Arborist Site Inspection Impact Assessment

Client:	Kosciuszko Thredbo, Mr. Euan Diver
Date of inspection	22 Oct 24
Address	Village Green, Friday Drive THREDBO NSW
Arborist completing inspection:	Andrew Downing Senior Arborist Assess Trees at AQF 5, QTRA Licenced User

A request from Euan Diver was received to inspect two trees located on the edge of the village green and inside the children's playground area for the impact to tree health from proposed storm water trenching work.

Typical TPZ and 10% encroachment detail

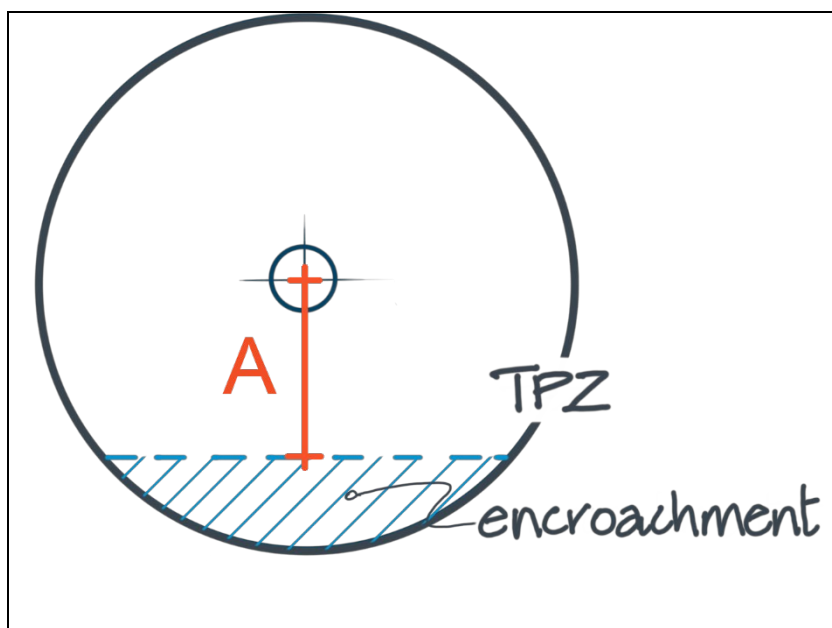
There are proposed trenching works planned to upgrade the storm water service from the village green that will be directed between the two trees and approx. 6m from both trunk bases. See attached image.

Any encroachment by trenching into the Tree Protection Zone (TPZ) that will cause damage to tree roots will have a negative impact on tree health and should be avoided. While a ten percent encroachment is permissible anything above this should be avoided. Any encroachment over thirty percent can cause partial decline or whole tree death.

Encroachment into the Structural Root Zone (SRZ) will cause instability and can lead to whole tree failure and risk of harm to any users of the target areas beneath the tree.

Distance (m) for minor encroachment (10%)	9.3
Distance (m) of trench line from trunk centre	3.0
TPZ radius (m)	13.6
SRZ radius (m)	1.5
TPZ area (m ²)	578.7
Encroachment area (m ²)	208.6
Encroachment (%)	36.0

Distance (m) for minor encroachment (10%)	5.8
Distance (m) of trench line from Trunk Centre	3.5
TPZ radius (m)	8.4
SRZ radius (m)	3.0
TPZ area (m ²)	221.7
Encroachment area (m ²)	53.8
Encroachment (%)	24.3

The proposed line of excavation through the TPZ of both trees exceeds the permissible encroachment allowance of 10 percent.

A solution to this should include planning for minimal impact excavation techniques such as Hydraulic Vacuum Excavation using high pressure water to cut through soil and vacuum suction to remove liquid debris or careful hand excavation. Any tree roots encountered must be avoided and left undamaged. Minor roots less than 20mm diameter may be cleanly cut using loppers or a hand saw.

Backfilling of trenches post works should be done using washed river sand and watered in to ensure any air pockets are completely filled.

The area beneath the trees and inside the TPZ should be mulched with organic mulch to a depth of 100-150mm.
